**DRAINAGE PLAN FOR THE REPLAT OF
LOTS P-1, Q-1 & R-1
BLOCK 4 THE PALISADES**

ROUGH GRADING PLAN

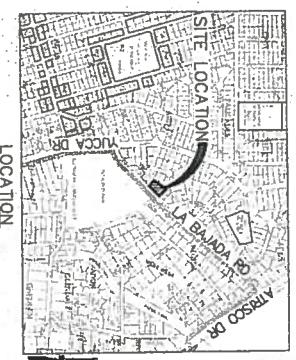
*Dance
these
parts of
lot line*

Hydro 30 (dining)
each 136 road,
paving 14 Apr 14
